ALERT SERVICE BULLETIN

UH-1H-II-17-28

MODEL AFFECTED: UH-1H-II

SUBJECT: MAGNETIC BRAKE ASSEMBLY 204-001-376-003
INSPECTION AND REPAIR OF.

Figure 1. Magnetic brake assembly.

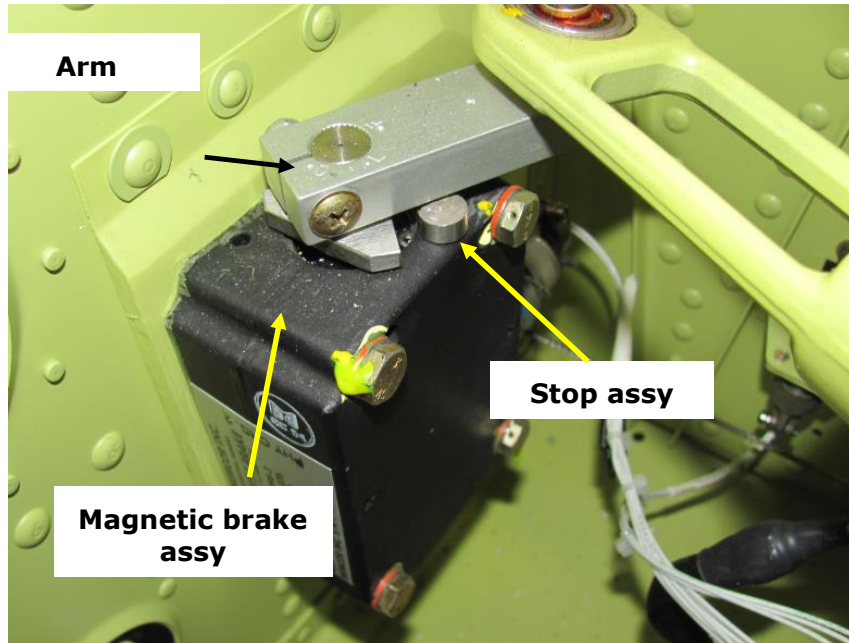
1. Prepare the helicopter for maintenance.
2. Gain access to the cyclic and anti-torque magnetic brake assembly.
3. Perform a detailed visual inspection of the stop assemblies (Figures 1 and 2). Figures 3 and 4 show a stop assembly found debonded.

Figure 3. Stop assembly with debonded shaft.

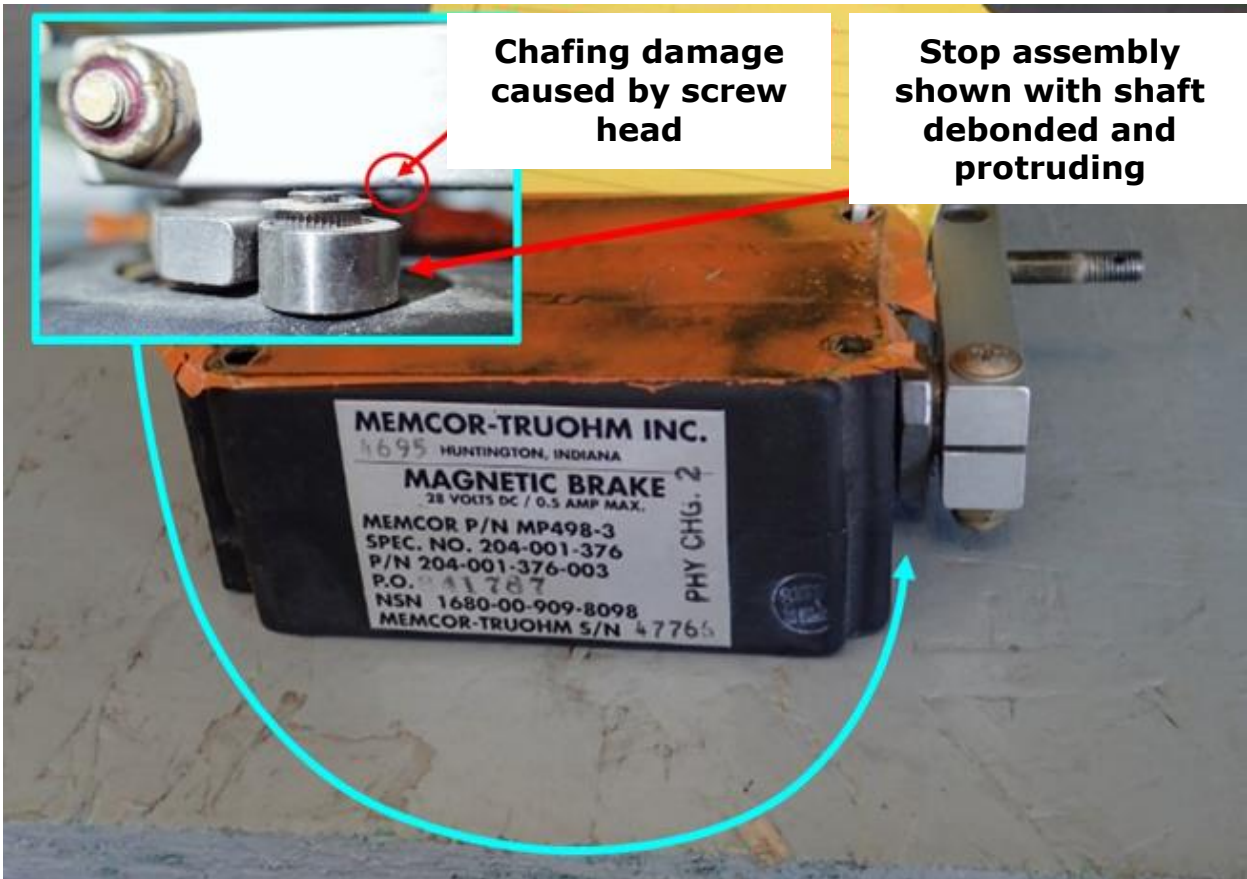
4. Pull on the stop assembly by hand to verify if the stop shaft is debonded from the housing assembly. If the shaft shows evidence of debonding, inspect the lower side of the arm for possible chafing damage. Repair allowable damage and then accomplish Part II. The maximum allowable mechanical damage is 0.030 inch. Repair allowable chafing damage as follows:

- a. Using 220 grit of finer abrasive cloth or aluminum oxide paper, polish out mechanical damage found within the allowable 0.030 inch
 - b. Apply aluminum alloy chemical film treatment to the repaired area (BHT-ALL-SPM).

Figure 4. Shaft removed from housing.

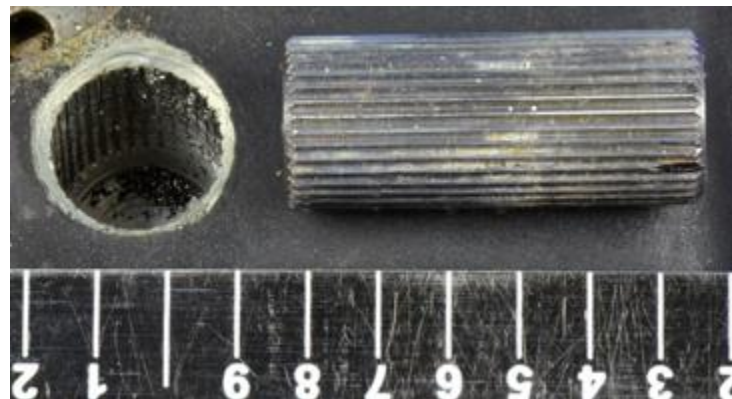
4. Remove the stop assembly from the housing. (Figure 4)
5. Thoroughly clean adhesive residue from the shaft and the housing bore. If the splined stop requires removal from the shaft, index mark the stop, the shaft and the housing to ensure installation at the same location.

Figure 5. Adjustable Stop Assembly Installation

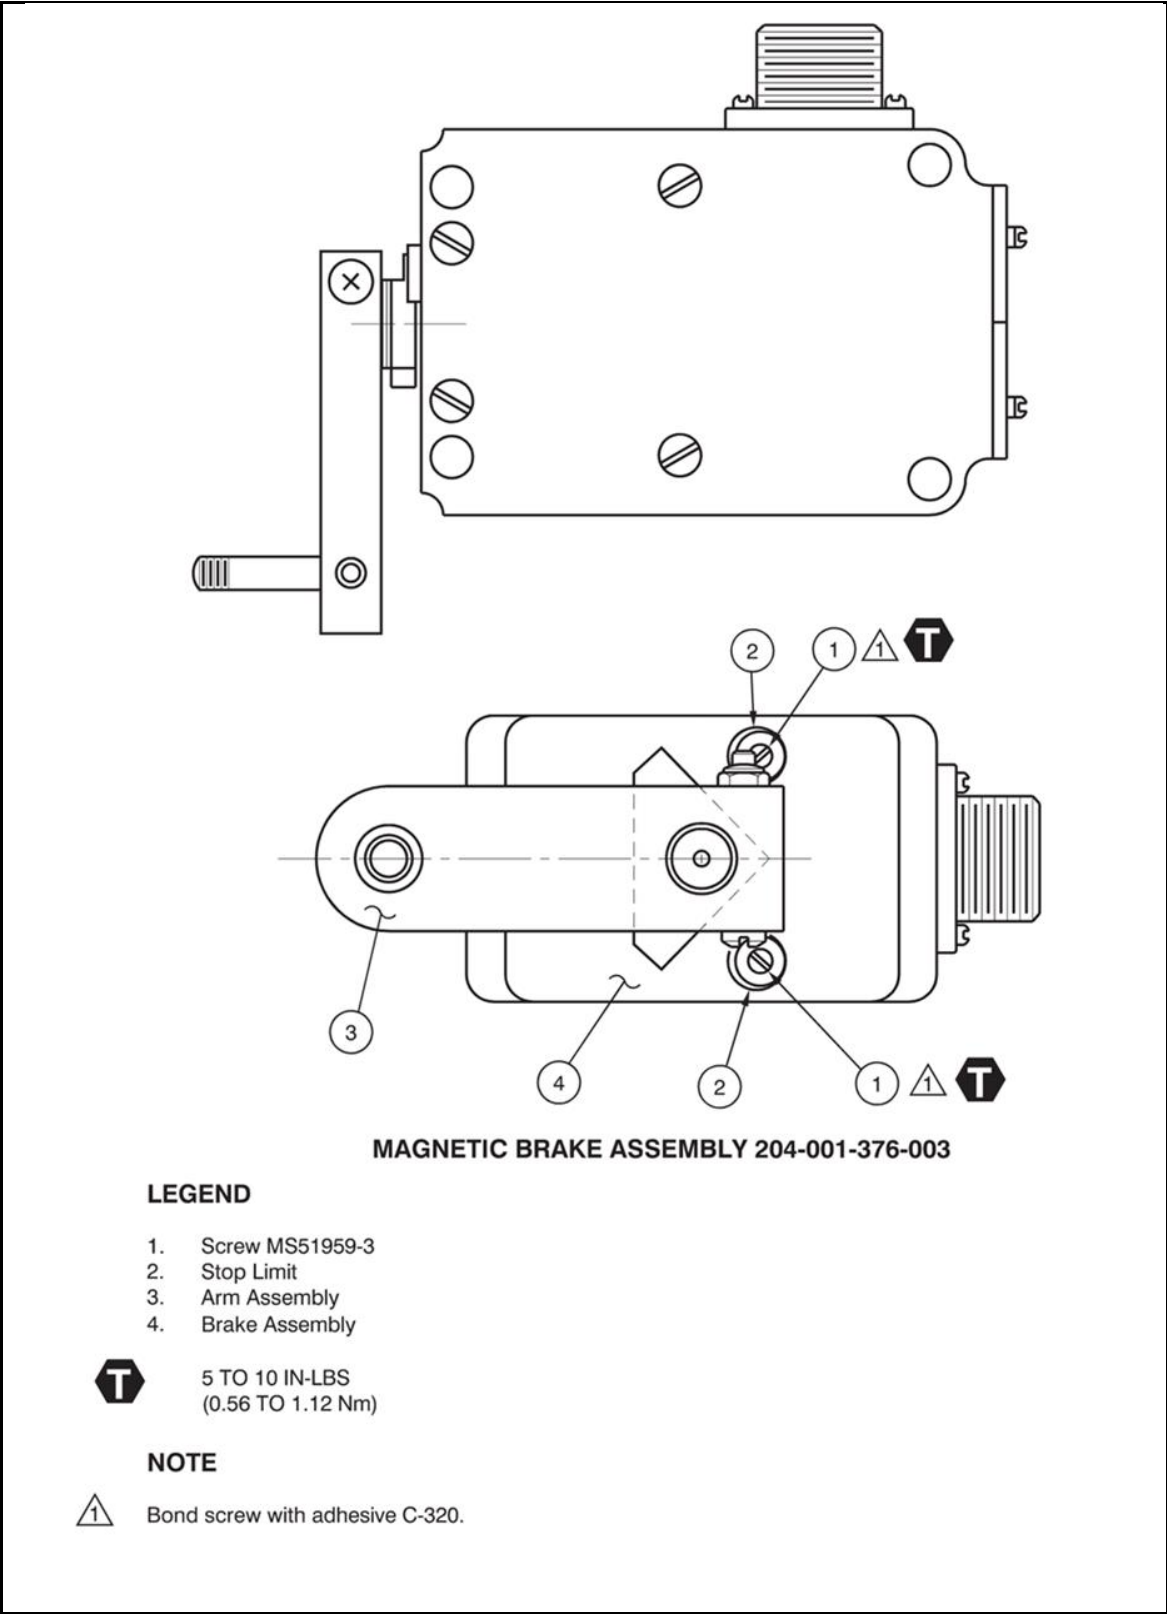
10. Verify/adjust stop limits to achieve the arm assembly travel. If the screw is removed from the shaft, reinstall with adhesive (C-320) and torque to 5-10in-lb. (Figures 5 and 6)

Figure 6. Stop Assembly Travel

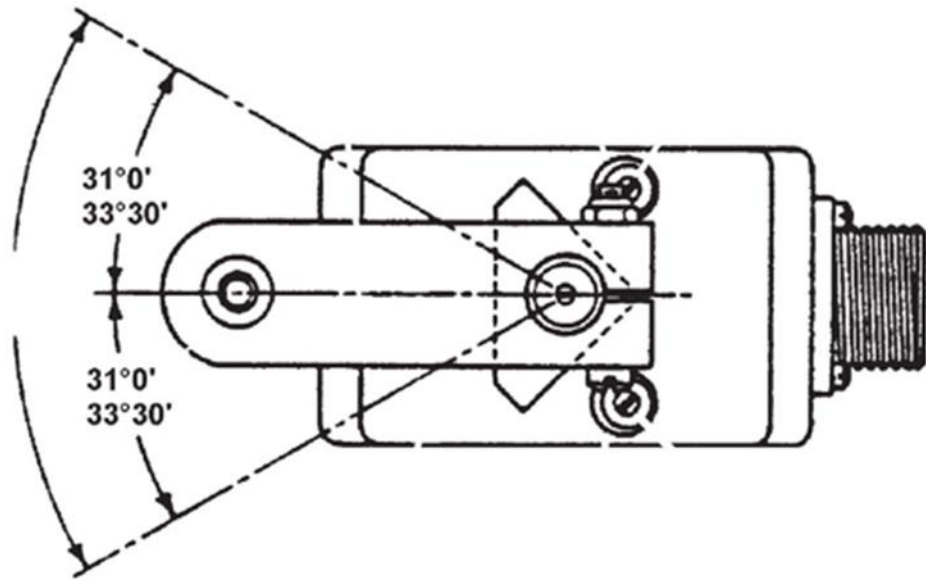
Regardless of arm letter indexing, total travel of the arm in relation to the stops is the same. Arm position shown would be for a cyclic controls installation.
